Haringey Civic Centre

Additional Architectural Information
following LBH Carbon Management
Response

HCC-HBA-XX-XX-RP-A-081001

This document is provided following receipt of the LBH Carbon Management Response dated 18/8/23 and provides additional information to support the planning and listed building consent application for the proposed refurbishment and extension of the London Borough of Haringey Civic Centre.

Typical detail (punched window)

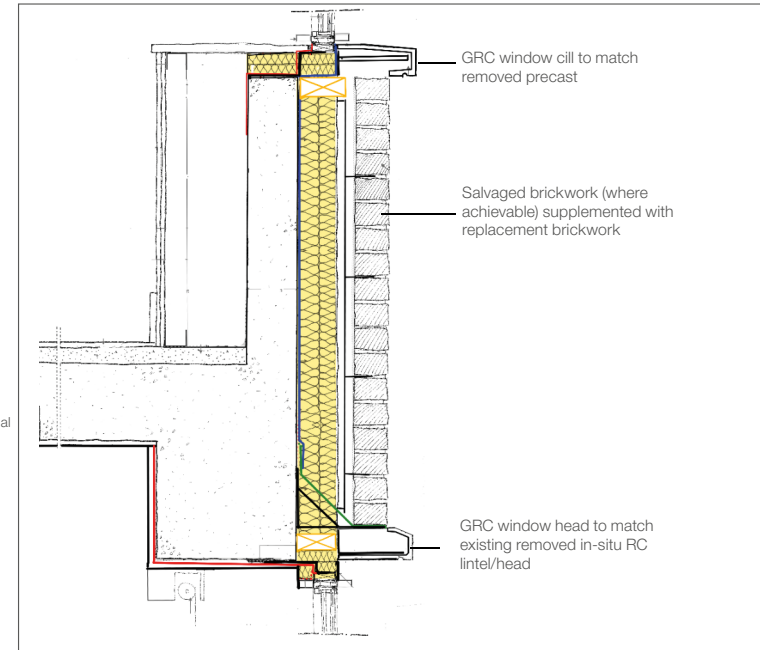
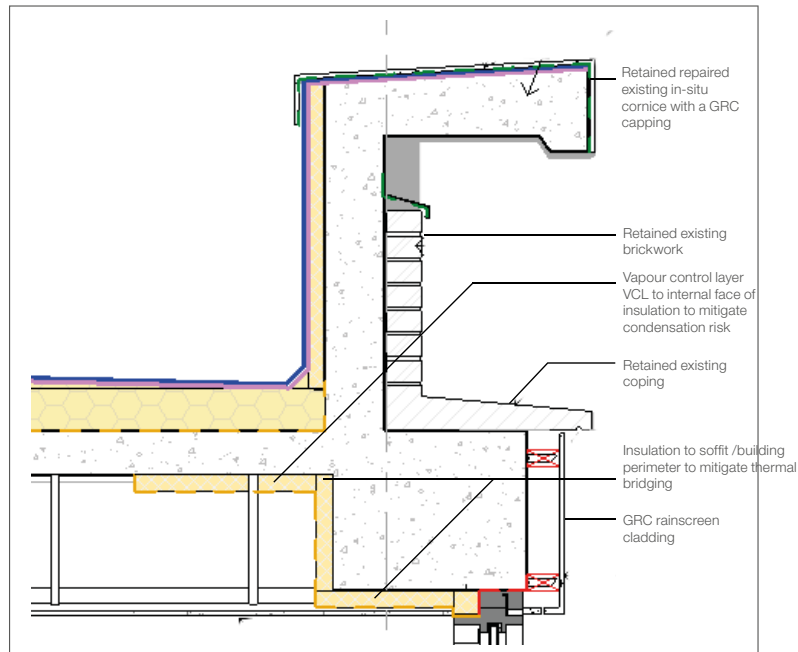
- External appearance and fabric retained as far as reasonably practical & refurbished
- Embodied carbon reduced
- Thermal bridging mitigated through provision of insulation to structural soffits at perimeter of building
- Condensation risk mitigated through provision of control layer to inner face of insulations

- External appearance substantially altered
- Existing fabric lost or substantially modified (a significant proportion of the original bricks likely will be damaged during deconstruction due to high cement content of the mortar and window surrounds would have to be replaced - the option above proposes GRC to match the proposed adjacent panels)
- Additional overall wall build-up (thickness) would increase by 170mm minimum.

Cornice detail

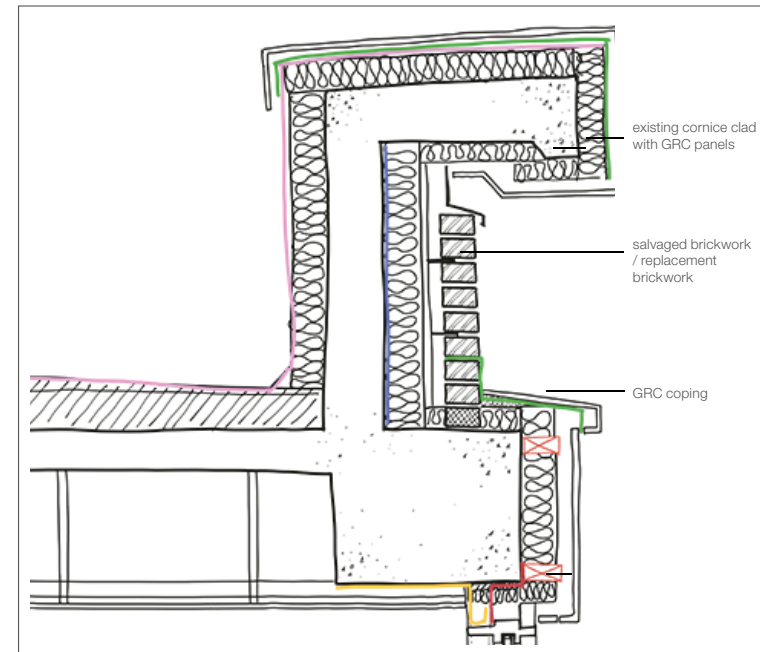
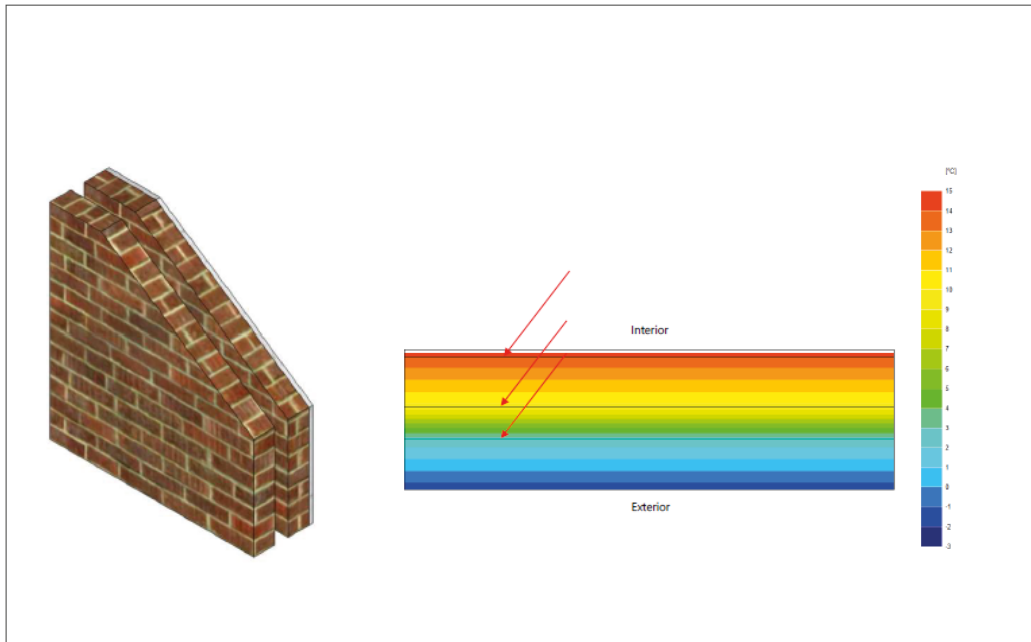
- External appearance and fabric retained as far as reasonably practical & refurbished
- Embodied carbon reduced
- Thermal bridging mitigated through provision of insulation to structural soffits at perimeter of building
- Condensation risk mitigated through provision of control layer to inner face of insulation

- External appearance substantially altered
- Existing fabric lost or substantially modified (a significant proportion of the original bricks likely will be damaged during deconstruction due to high cement content of the mortar and window surrounds would have to be replaced - the option above proposes GRC to match the proposed adjacent panels)
- Additional overall wall build-up (thickness) would increase by 170mm minimum.

Existing Uninsulated Cavity Wall

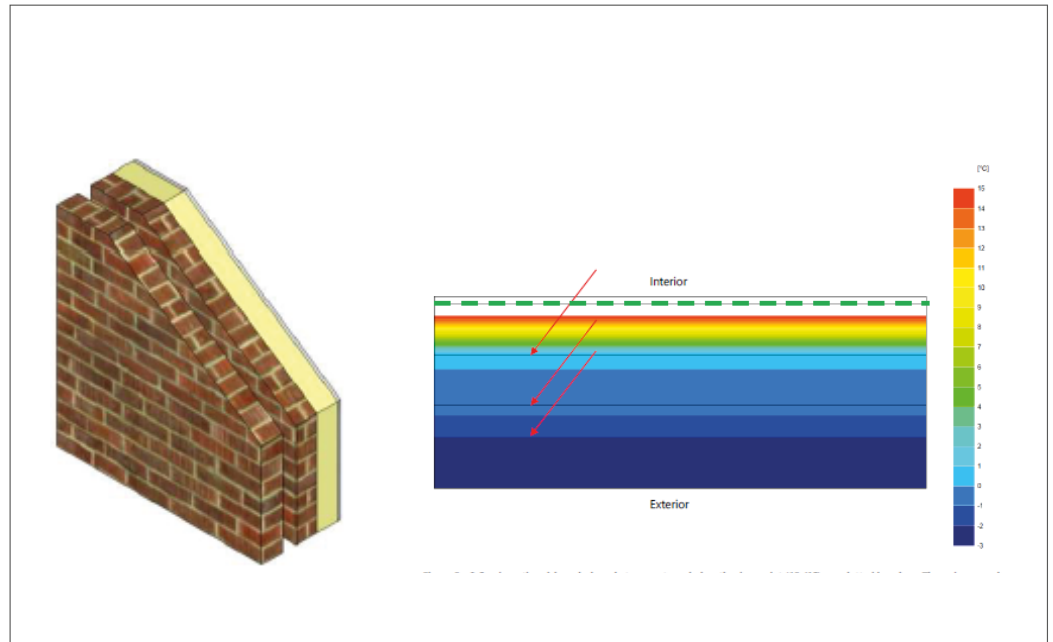
- Achieves U-Value c. 1.845 W/m²K
- Red arrows show the condensation risk

- Achieves U-Value c. 0.3 W/m²K
- Red arrows show the condensation risk
- VCL (green dashed line) implemented to mitigate condensation risk

2 Indicative PV Layout

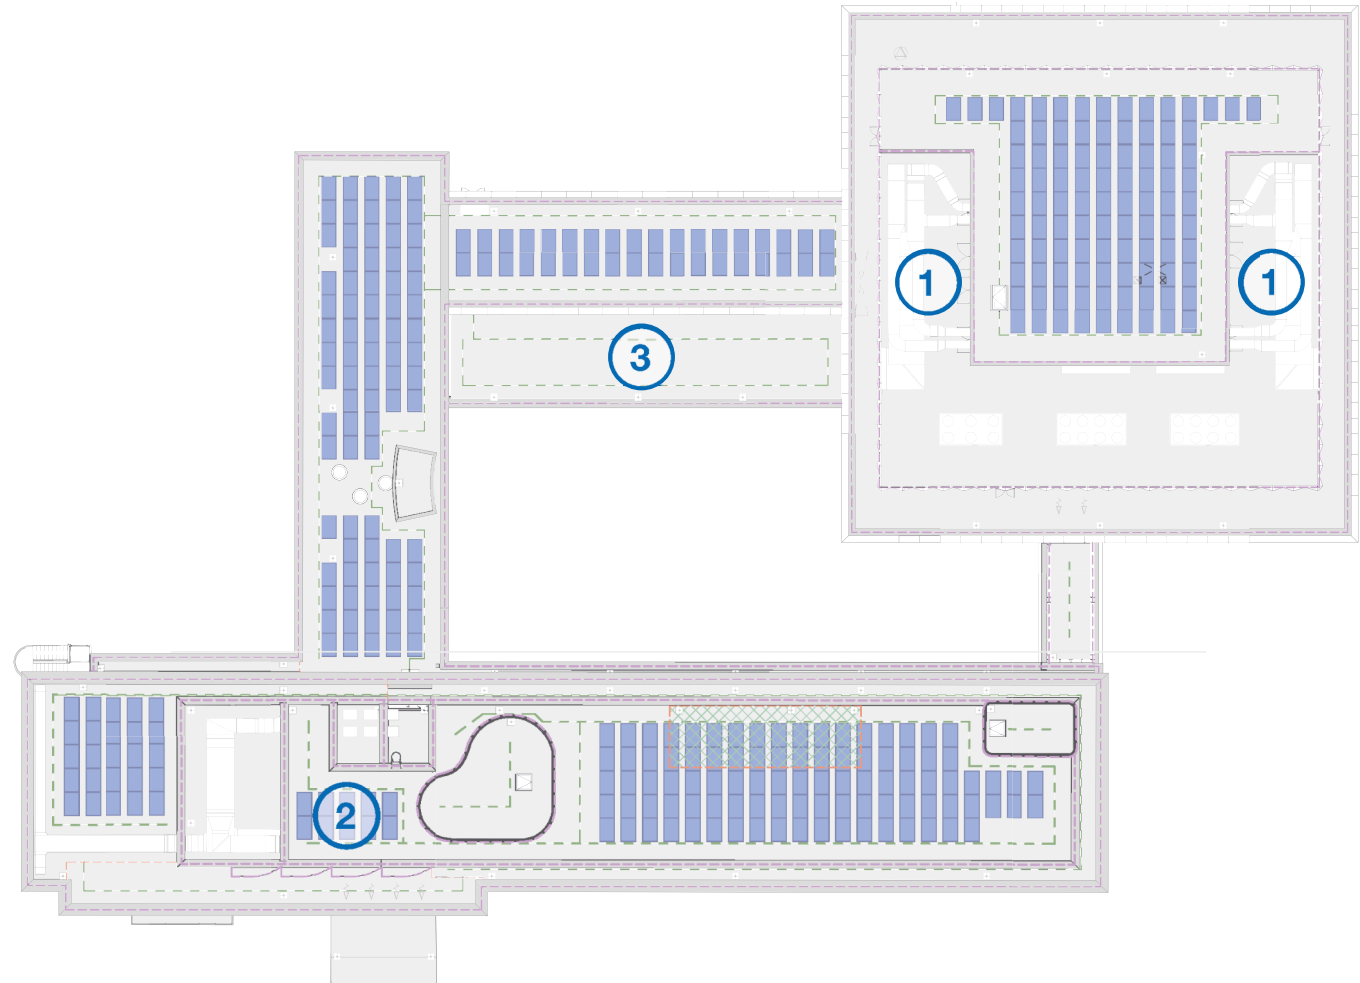
Following design development since the submission, the panels have been redistributed slightly, however the proposal provides the equivalent quantity and output as the layout previously submitted.

1. PVs omitted above open plant space canopy, due to the heat output of plant equipment below and buildability/sequencing issues.
2. 10 No. PV panels above the former plant space.
3. No PV panels located on the lower terrace of the west link block due to overshadowing.
